City of Pembroke Pines
Planning & Economic Development Department
601 City Center Way 3rd Floor
Pembroke Pines FL, 33025

Agenda Date:	September 9, 2021	Application ID:	SP 2021-08
Project:	Tesla Charging Station At Wawa Hiatus Road	Project Number:	PRJ 2021-10
Project Planner:	Cole Williams, Planner / Zoning Technician		
Owner:	Imperial Hornet Developers Florida LLC Wawa Inc Finance dep	Agent:	Sheryl Blasi
Location:	1600 South Hiatus Road		
Existing Zoning:	B-3 (General Business)	Existing Land Use:	Irregular 5.52 du/acre flexed to Commercial
Reference Applications:	SP 2017-03, ZV 2017-14, ZV 2017-04, ZV 2017-03, ZV 2017-02, ZC 2017-02, SP 2015-01, SP 2014-22, MSC 2010-07, SP 2008-02, MSC 2007-71, SP 2006-53, ZC 2005-06, ZC 2005-07, ZC 2003-02, AM 2003-07		
Applicant Request:	Installation of 8 Tesla charging stations		
Staff Recommendation:	Approval		
Final:	<input checked="" type="checkbox"/> Planning & Zoning Board	<input type="checkbox"/> City Commission	
Reviewed for the Agenda:	Director:  Planning Administrator:

Sheryl Blasi, agent, is requesting approval for the installation of 8 Tesla charging stations, associated equipment and landscaping in the northernmost parking field of

C-2

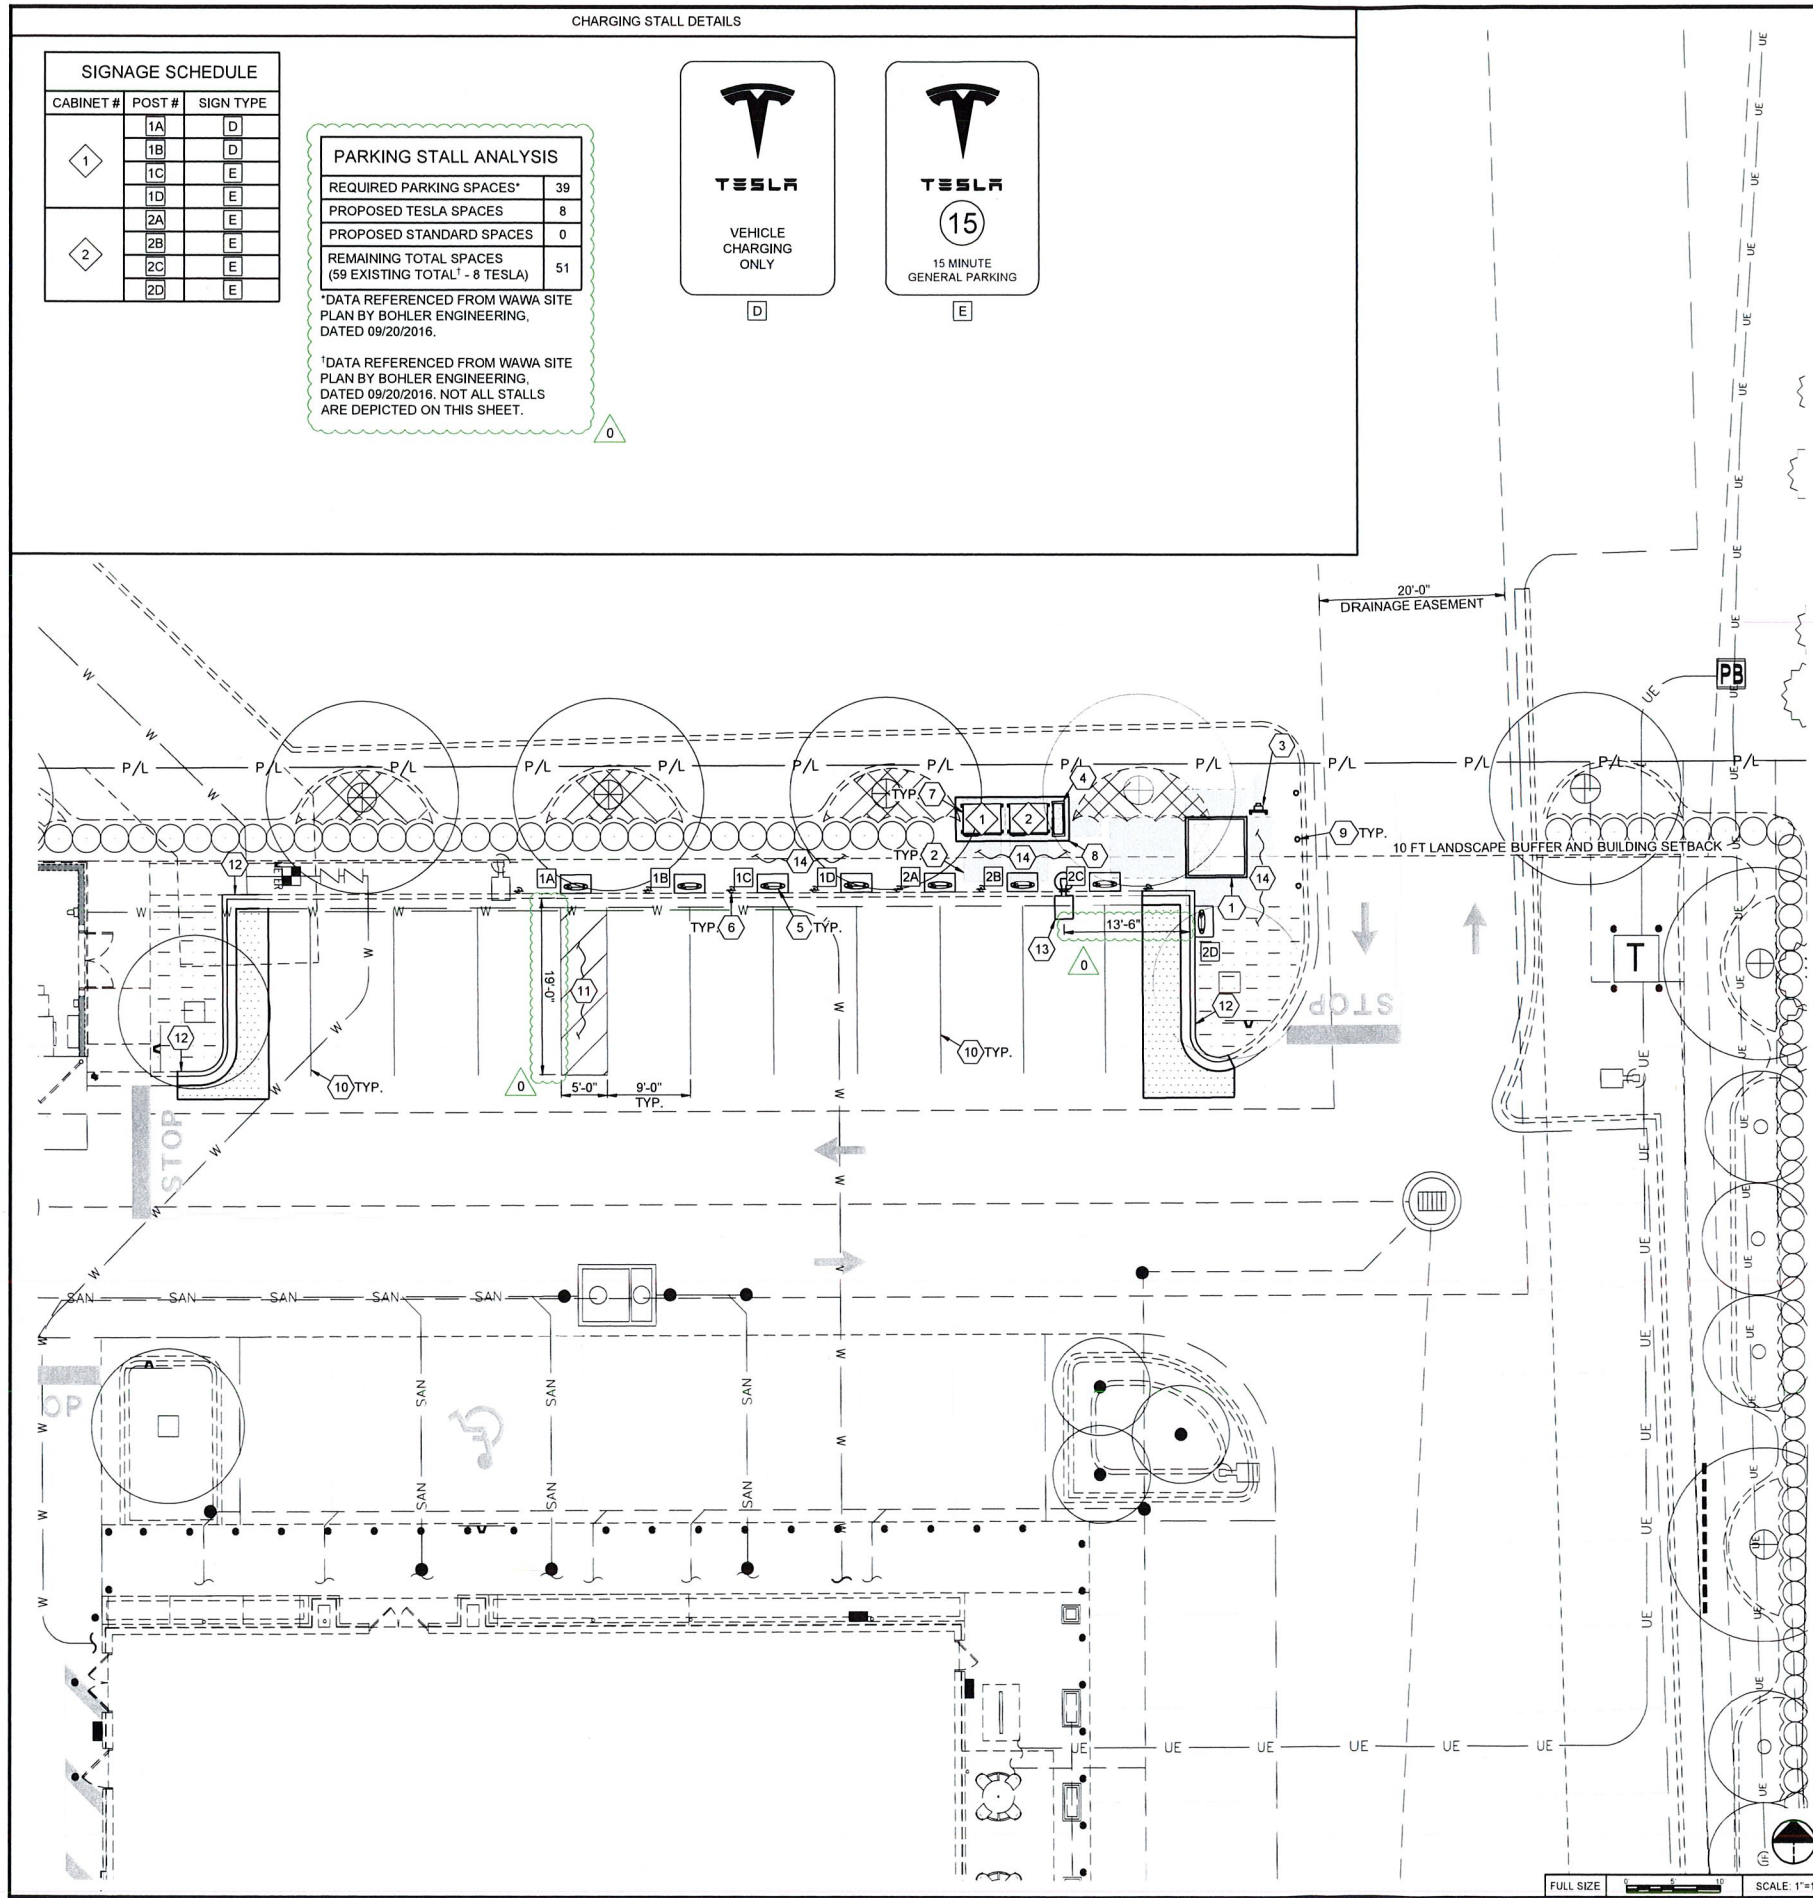
1. Site Plan, Sheet C-2 – Provide in the Site Plan or in a Pavement Marking and Signage Plan reflecting the appropriate pavement markings for the parking lot areas where proposed asphalt pavement is to match existing. Standard Parking Space markings must be corrected/refurbished to conform the attached City Standard R-41, 'Standard Parking Space Details', Sheet 1 of 3.

2. Site Plan, Sheet C-2 – Construction of the proposed asphalt pavement to match existing pavement must follow City Standard R-47. Provide a 'Pavement Restoration Detail' and reflect City Standard R-47, 'Asphalt Pavement Repair' on the 'Civil Details' sheet.

8. PARKING SPACE MARKINGS MUST BE CORRECTED AND REFURBISHED TO CONFORM THE CITY STANDARD R-41, 'STANDARD PARKING SPACE DETAILS'. SEE DETAIL ON SHEET C-5.

C-3

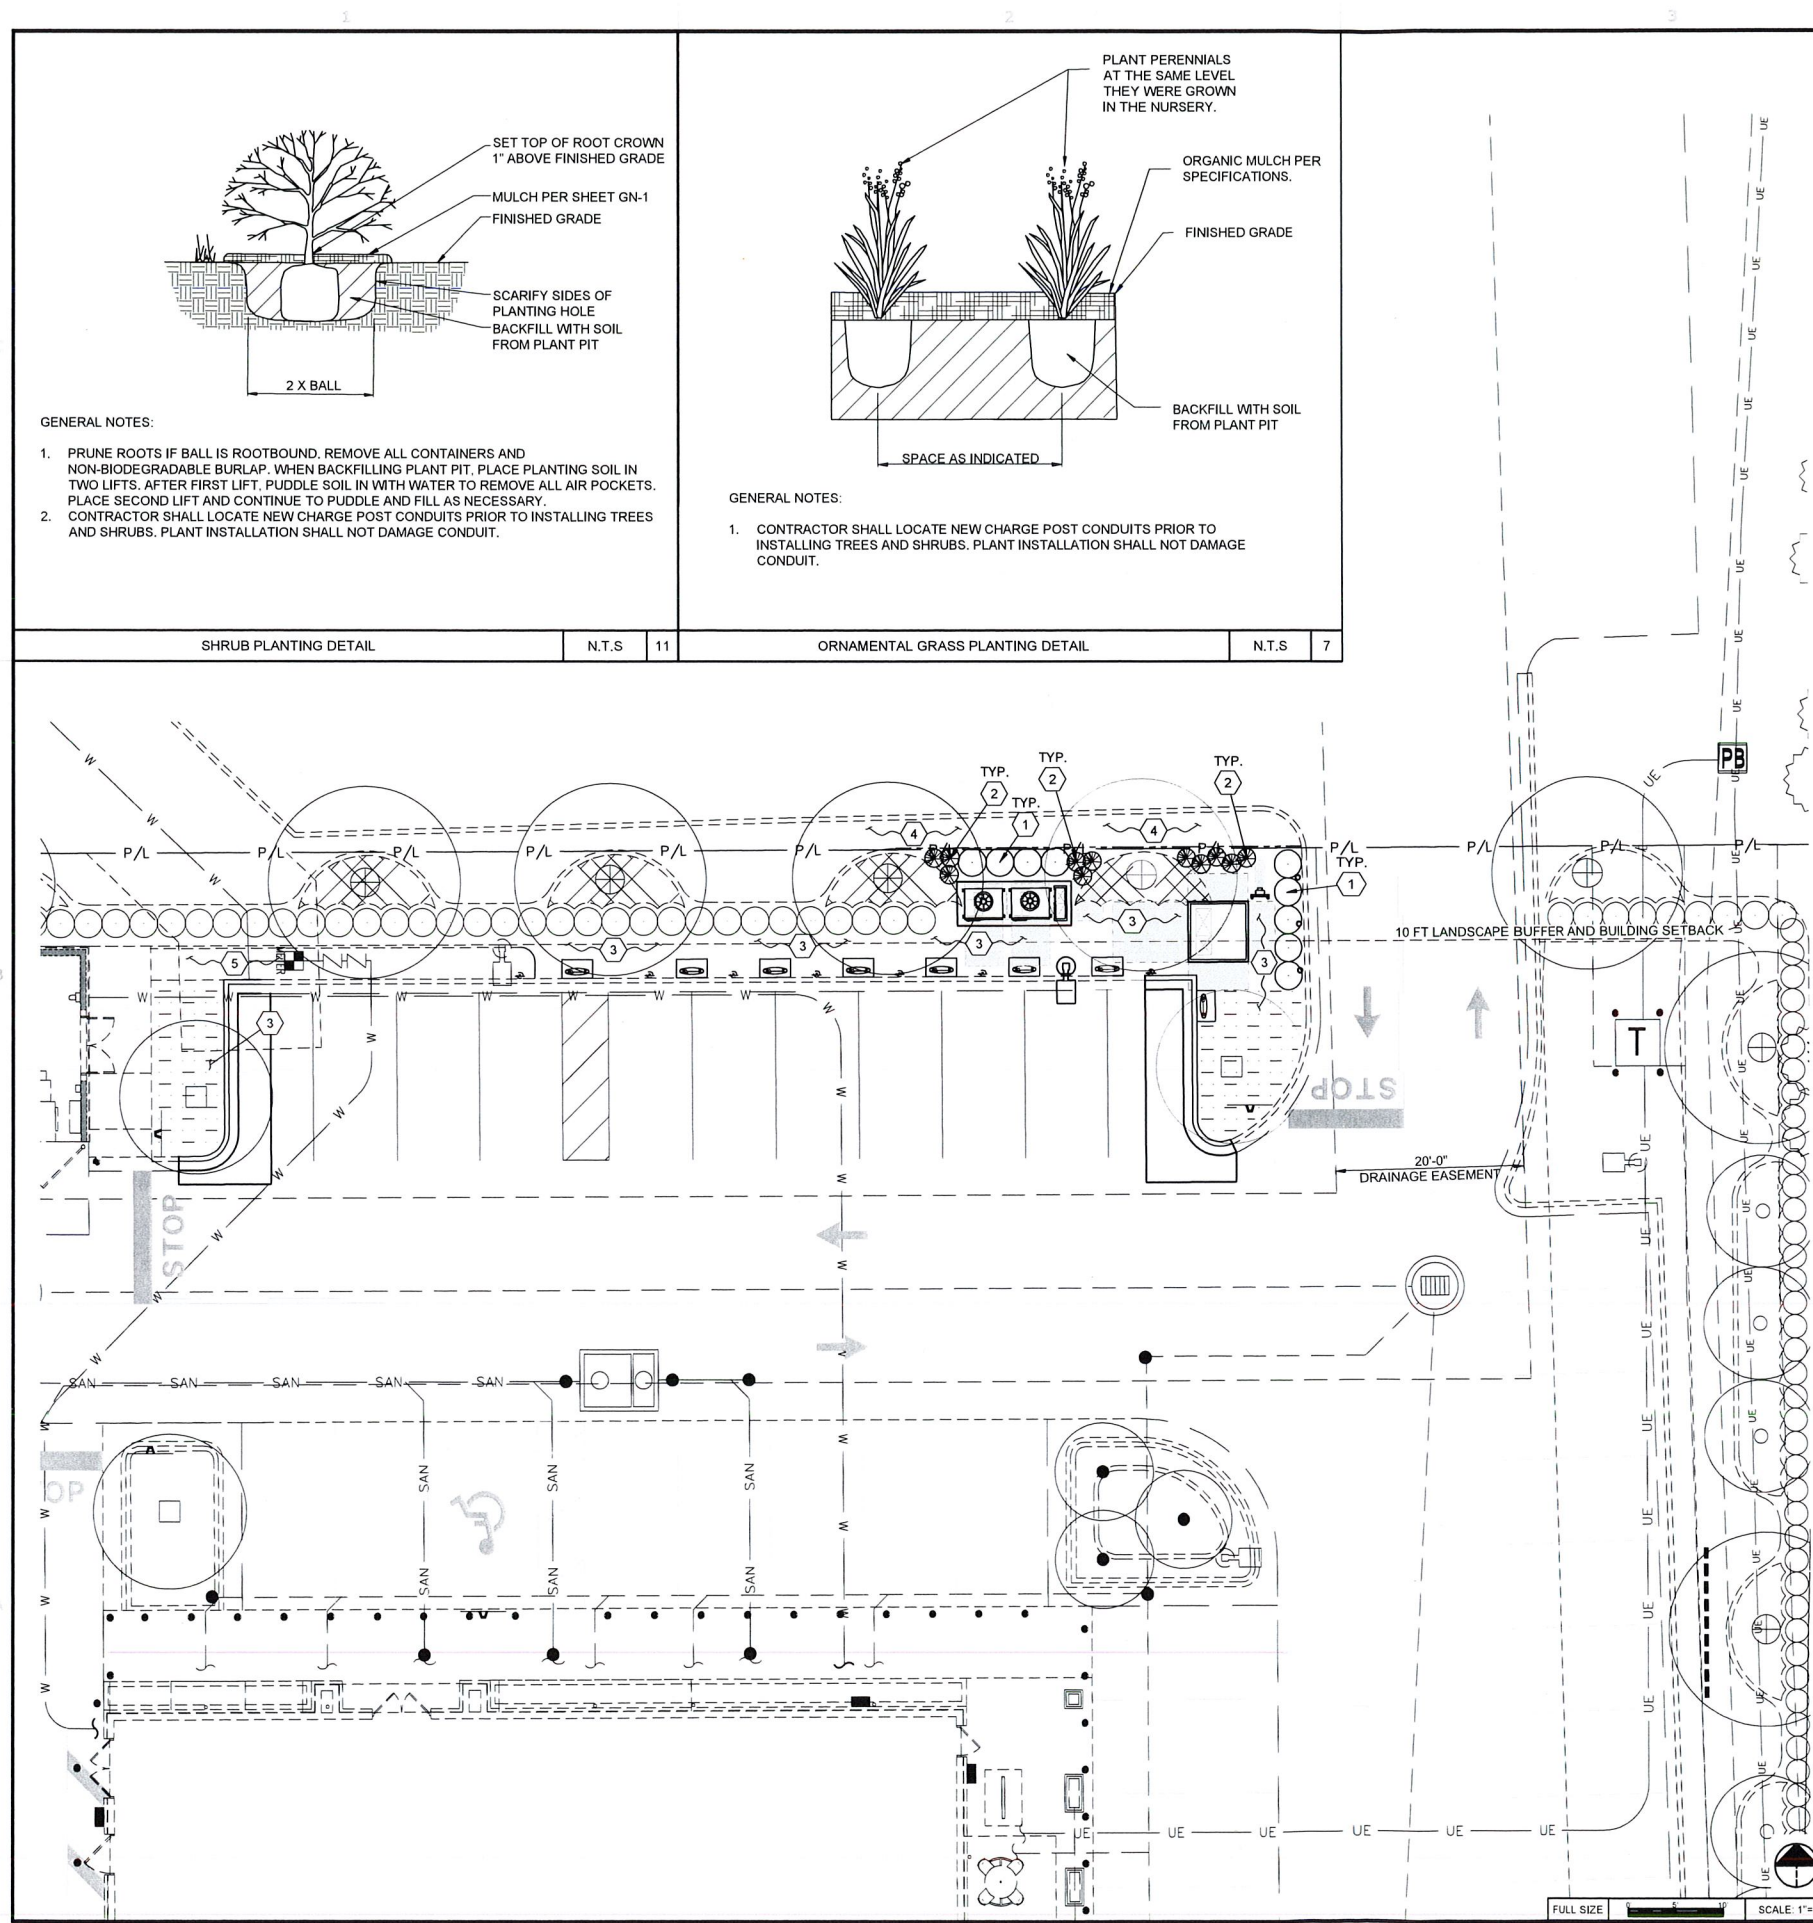
1. Per plans, re-locating existing material. Need to provide plating replacement detail for tree / shrub being relocated. As per City of Pembroke Pines Landscape Ordinance 155.661 (E) *“Utility structures, garbage, and refuse areas shall be screened with landscaping material to the extent that these areas are not visible at a maximum height of six feet from abutting properties or adjacent right-of-ways.”*
2. Irrigation must be working properly to ensure that all new and existing landscape material is adequately being irrigated. A “wet-check” shall be done at time of final inspection to ensure all irrigation heads are working properly etc.

Landscape comments have been addressed (Sheet C- 7/02/2021)

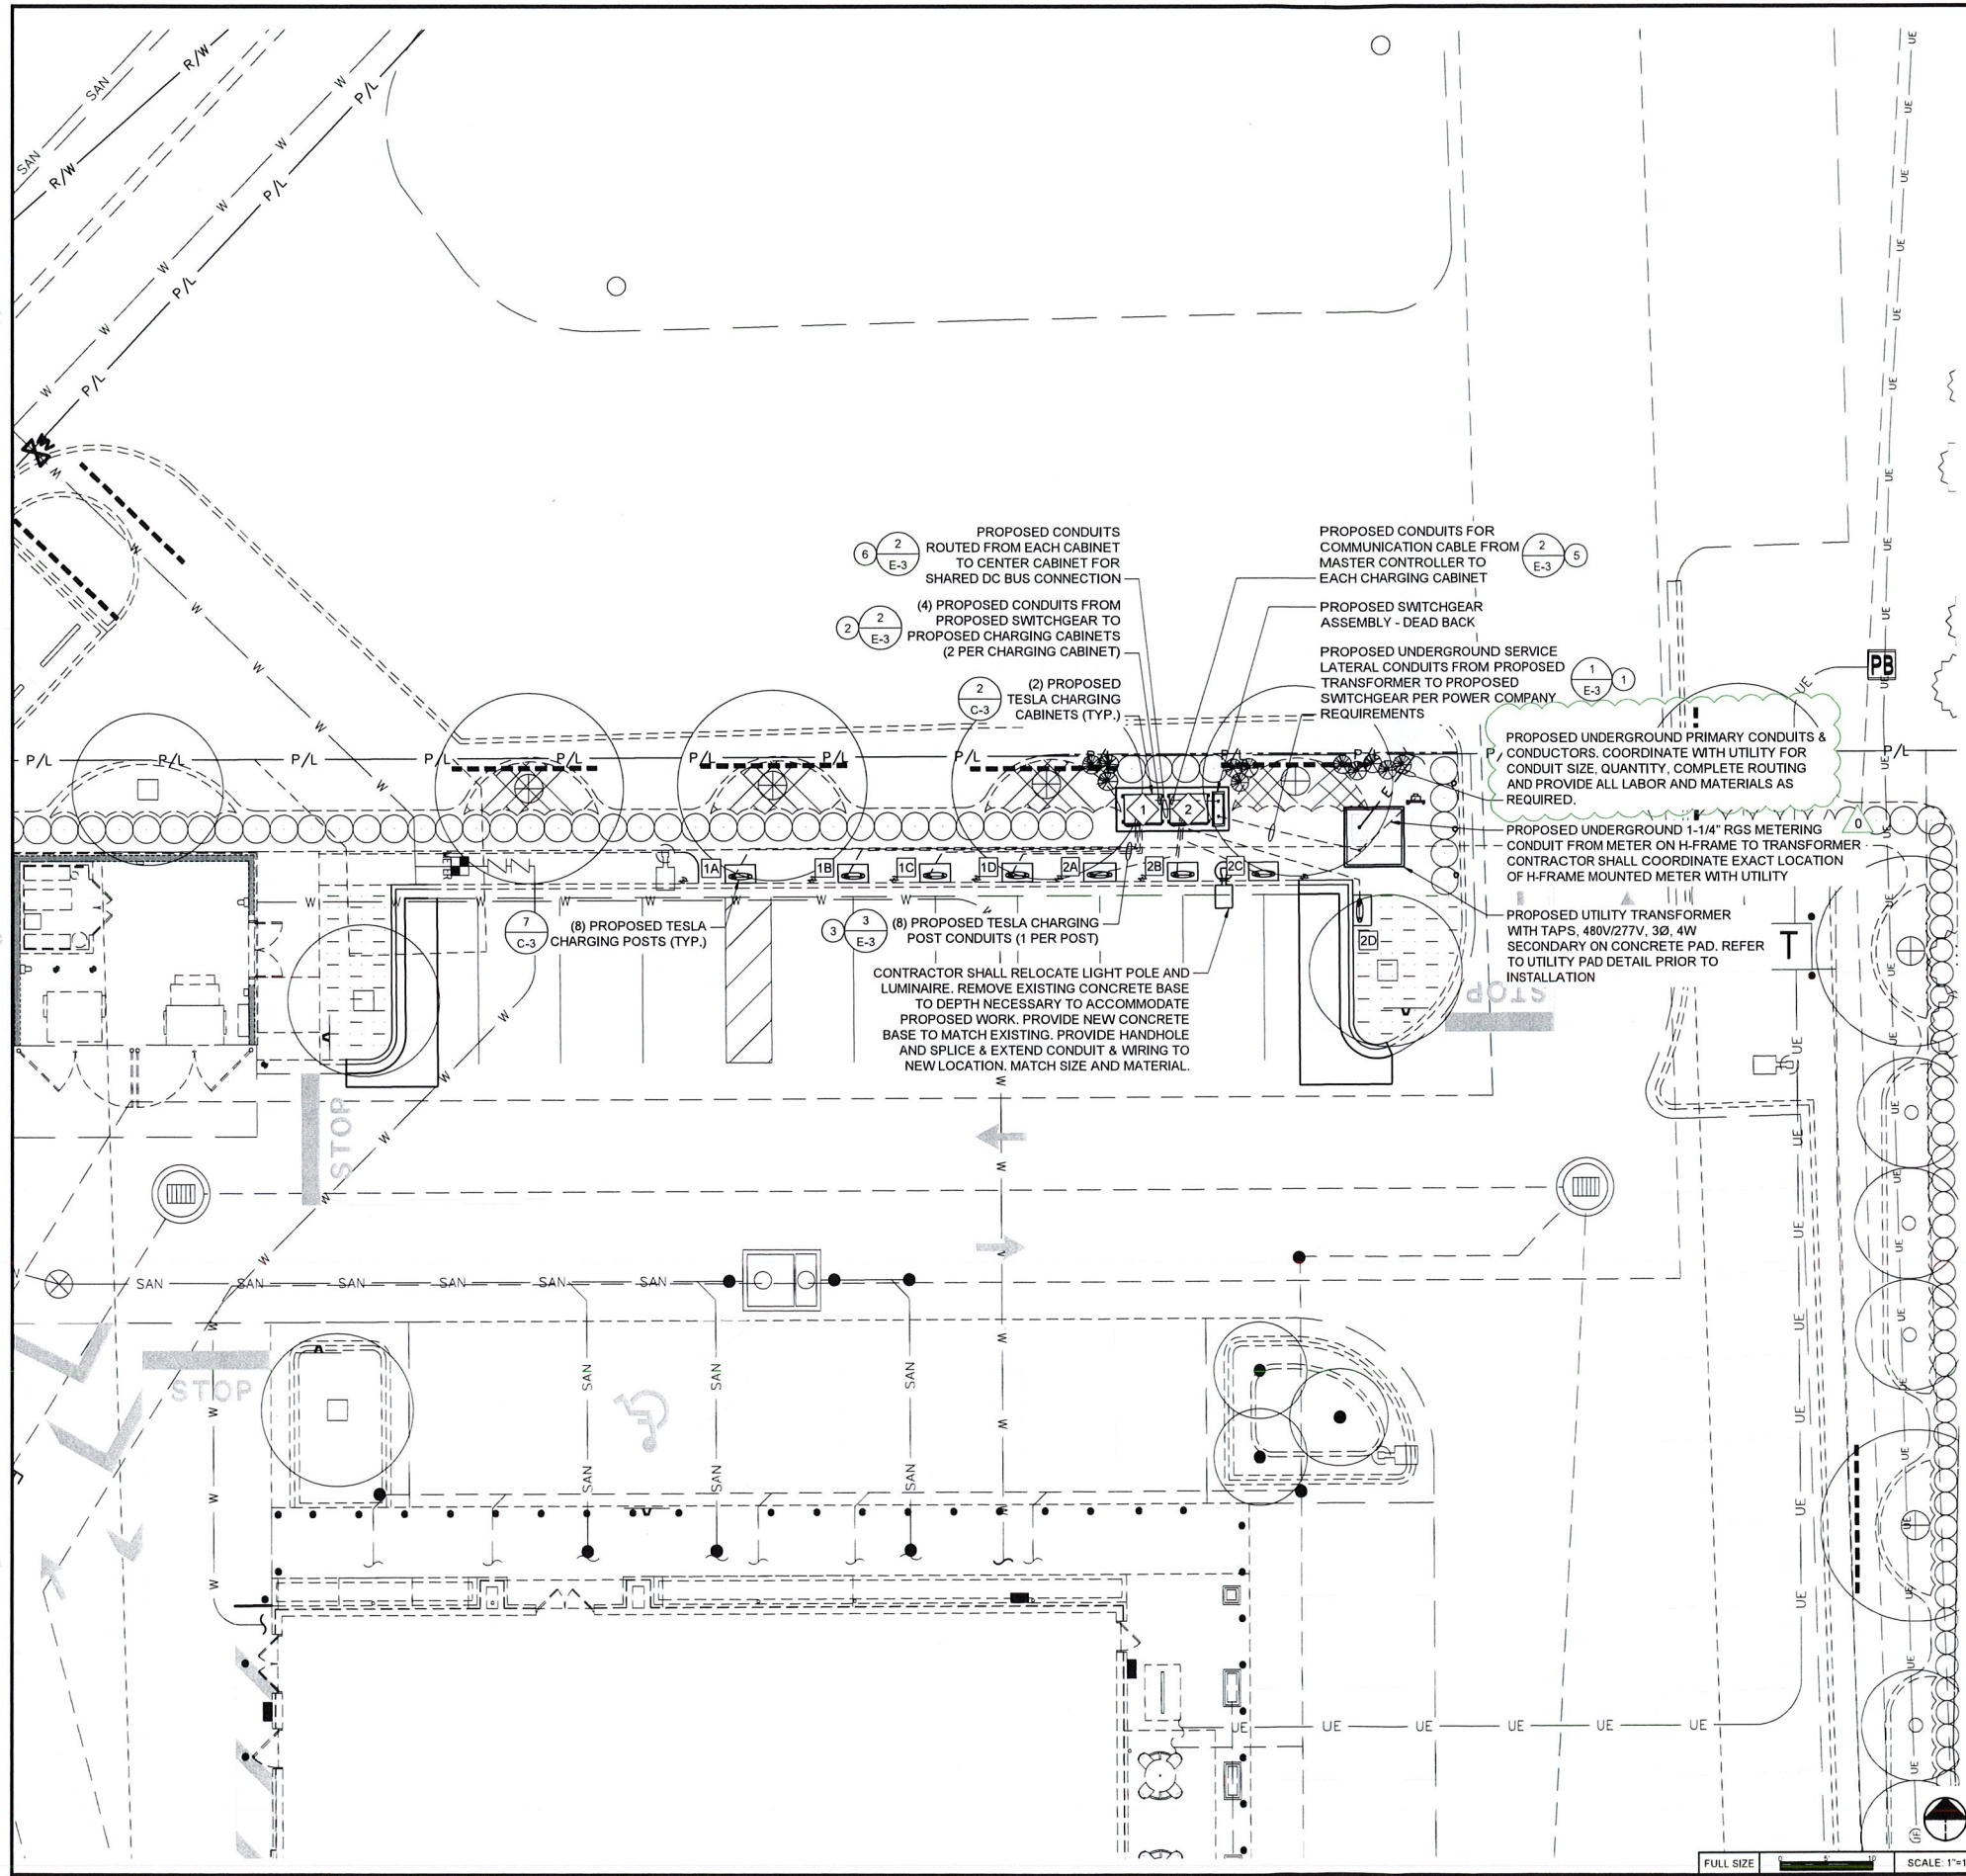
3. Electrical Equipment Plan, Sheet E-1 – Depict the entire length of the proposed directional bore from the proposed utility transformer to the point of connection with the electrical utility line. **Note** that a profile plan with grid elevations depicting the entire length of the directional bore and surrounding underground utilities must be provided in the Construction Permit for approval.
